ARBORICULTURAL ASSESSMENT REPORT

Sydney Modern

02 August 2018

Prepared for
NSW Planning & Environment

Figure 2 - Bark inclusion in primary junction of Tree 1118

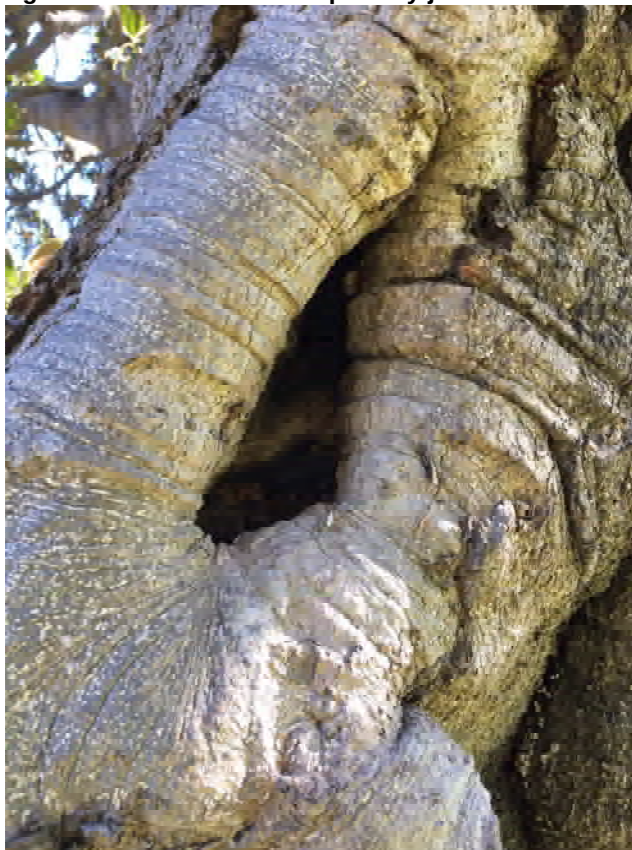
This mature tree is approximately 14.5m tall with a canopy spread of 18m. It has twin co-dominant trunks from 1.5m above the base with a DBH of 1130mm. This tree is in good health and condition with a dense canopy, moderate deadwood and epicormic growth. There is moderate apical dieback evenly distributed over the canopy. There is evidence of a bark inclusion within the primary junction on the eastern side of the trunk of this tree with evidence of decay within this junction.

is based on the total area of excavation extending no more than 1m from the back of the shoring as show on this drawing. This assessment shows that the Tree Protection Zone (TPZ) of this tree will be encroached by the proposed bulk earthworks by 25% and by the proposed Bicycle Parking Area by an additional 20% bringing the total area of the TPZ encroachment to 45%. This is significantly greater than the 10% minor encroachment as defined by AS4970-2009. The extent of encroachment is likely to be increased as the level of the Bicycle Parking Area is significantly higher than the base of Tree 1118 and additional filling may be required to marry these levels.

This tree is proposed to be retained within the proposed development as shown on Landscape Plan LD_DA_30-04 however the extent of the encroachment within the TPZ of the proposed earthworks and bicycle parking area are likely to impact on the health and condition of this tree and therefore the viability of this tree to be retained within the landscape in-situ. This tree is currently in good health and condition with a dense canopy, minimal deadwood and minimal epicormic growth however it was noted that there is a significant amount of apical dieback evenly spread over the entire canopy which is indicative of stress on this tree. This will further impact upon the viability of this tree to be retained in-situ.

The Structural Root Zone (SRZ) of this tree, which is defined by AS4970-2009 *Protection of Trees on Development Sites* as the area of root development required for the structural stability of the tree, is approximately 3.8m and is not impacted by the proposed bulk excavation based on a 1m offset from shoring.

In order to further investigate the total encroachment proposed for this tree, we recommend further investigation of the root plate of this tree by means of root mapping. Root mapping may be carried out using Ground Penetrating Radar (GPR) or by non-destructive excavation using an Air Knife. Please note that vacuum trucks or high pressure water are not suitable. Further investigation to be made into the proposed shoring methods to accurately determine the extent of excavation required for shoring.

Figure 7 - Tree 1363 (right)

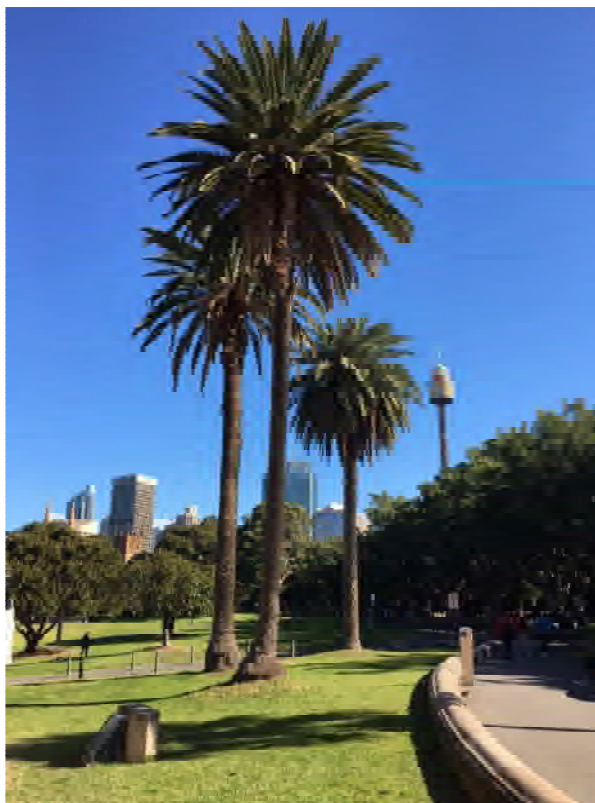
The Tree Protection Zone (TPZ) of this tree in accordance with AS 4970-2009 *Protection of Trees on Development Sites* will be totally encroached by the proposed development. This tree will not be viable to be retained under the proposed development.
